COMMUNITY DEVELOPMENT DEPARTMENT  
501 Delta Avenue ♦ Marysville, WA 98270 ♦ (360) 363-8000

April 16, 2024

Re: Undi Commerce Park – *Technical Review 4*  
PA 22008

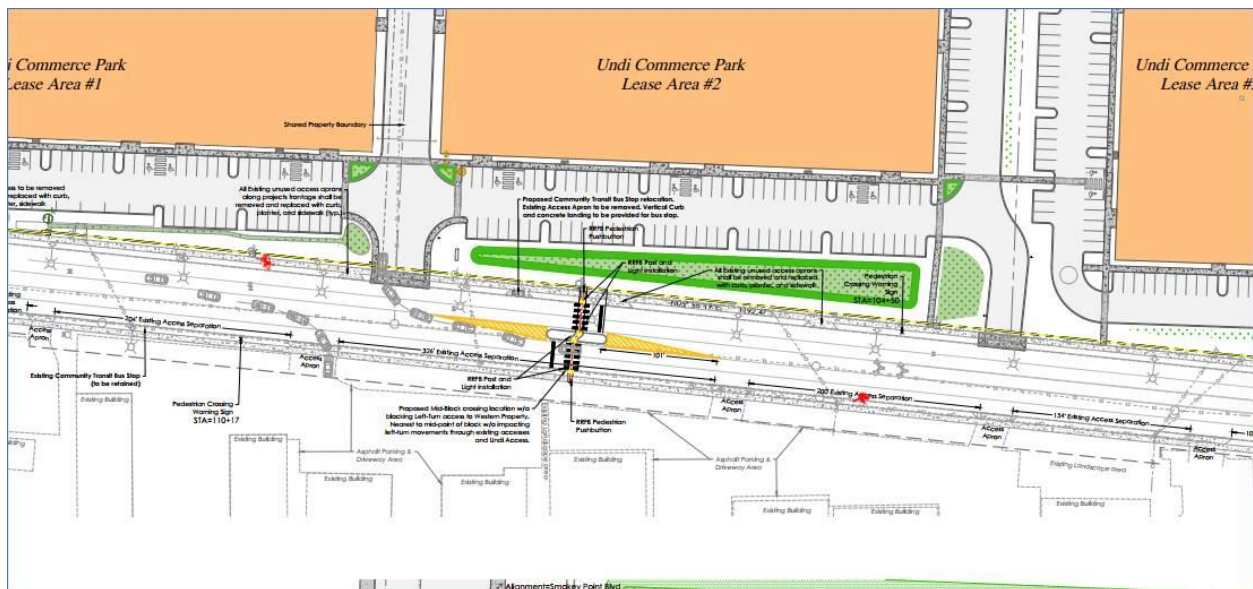
Our Design and Operations team reviewed the provided material and advised that they are not opposed to shifting the stop closer to the new crosswalk, however, north of the new driveway would be a better location.

While this means a longer walking distance for riders, it would also provide more visibility and safety compared to the proposed location, especially for vehicles turning left out of the property and not seeing traffic passing the bus.

Even if the stop stays at the revised location it would be better suited further north as it may place the tail of an articulated bus almost in the crosswalk.
